6.0 ADMINISTRATIVE CONTROLS

DAVIS-BESSE NUCLEAR POWER STATION
OFFSITE/ONSITE ORGANIZATION
FIGURE 6.2-1

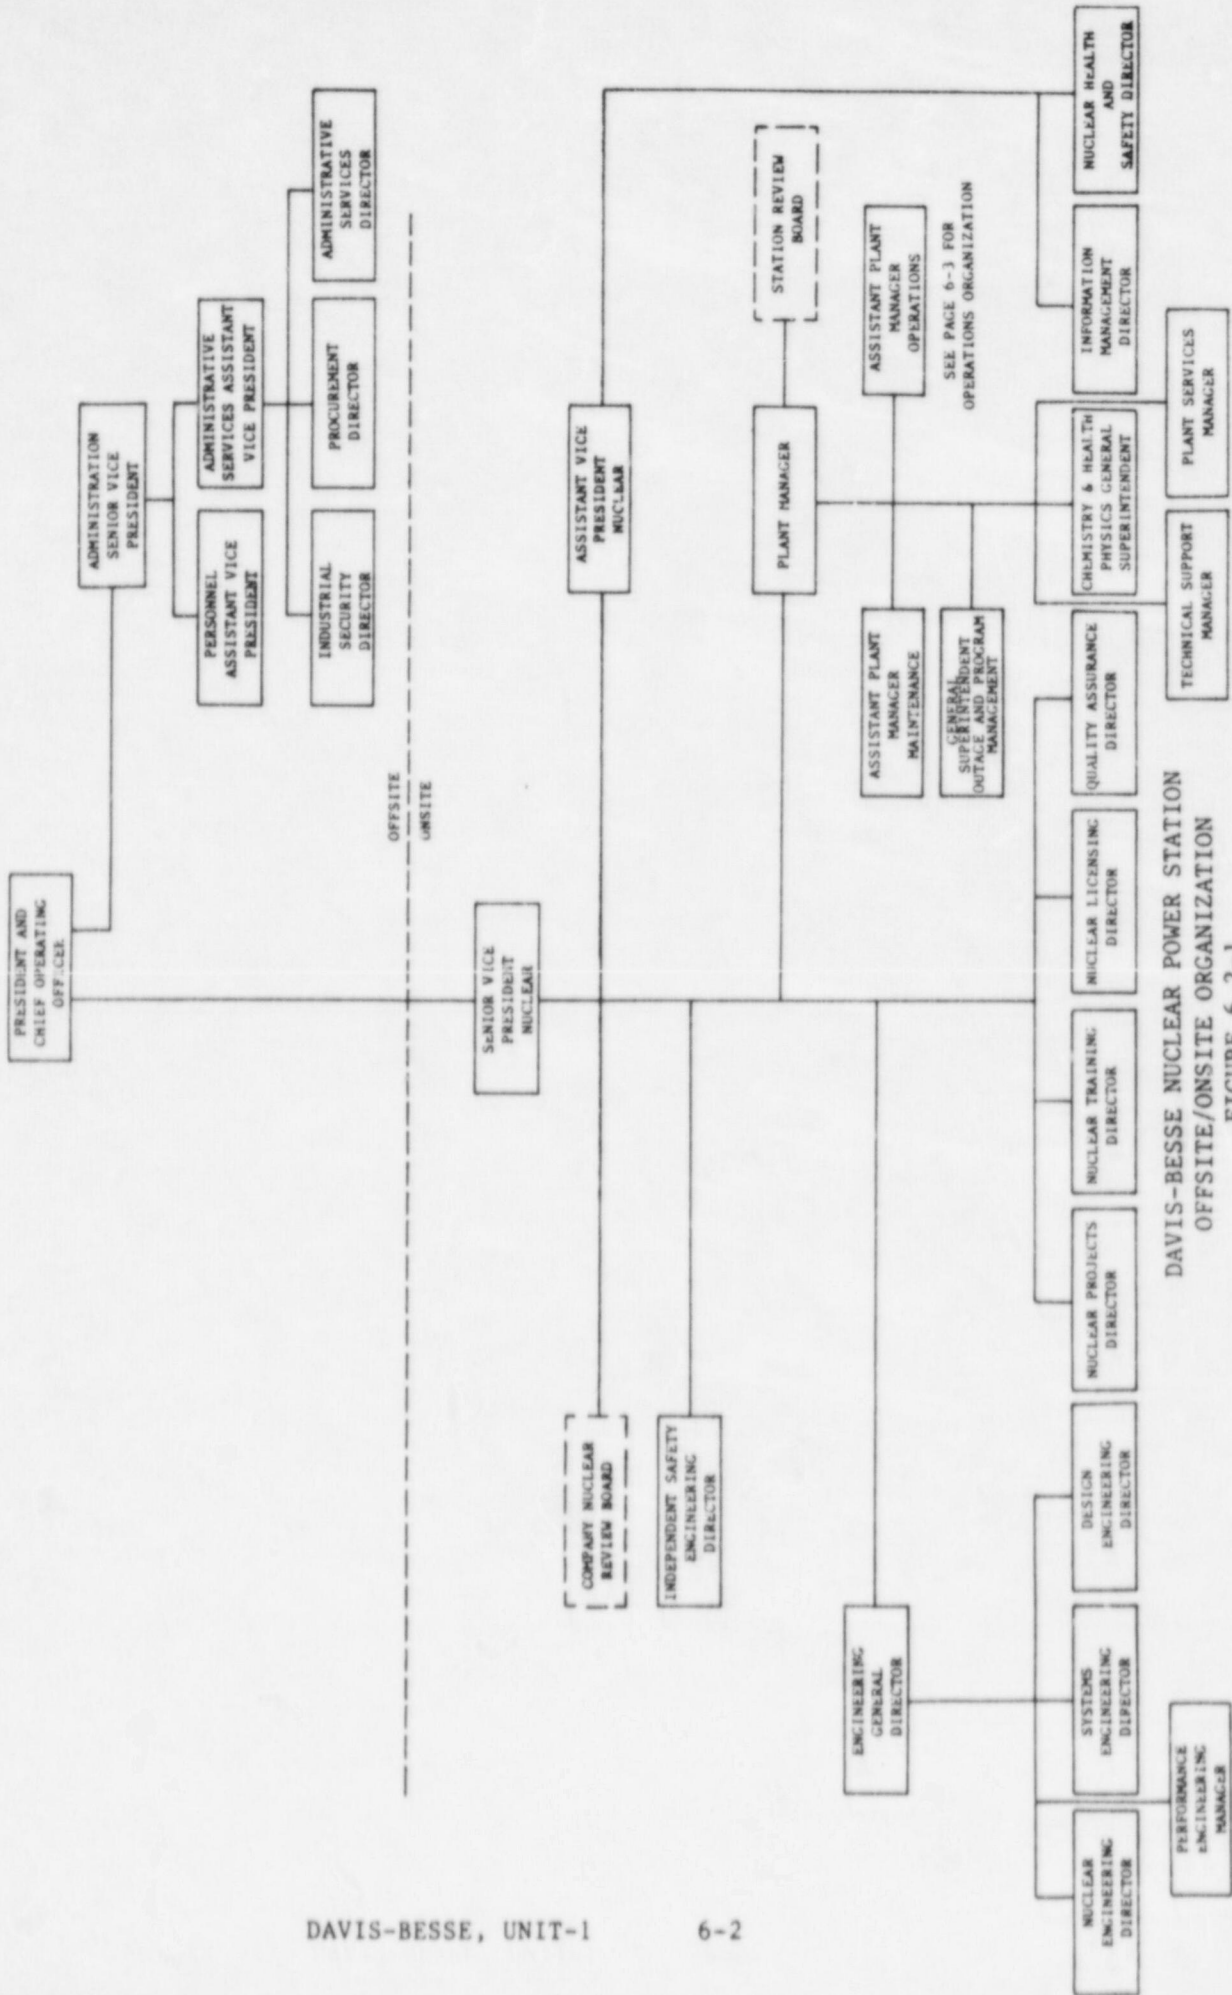
6.2.2 The Facility organization shall be as shown on Figures ~~6.2-2~~^{6.2-1 and} and:
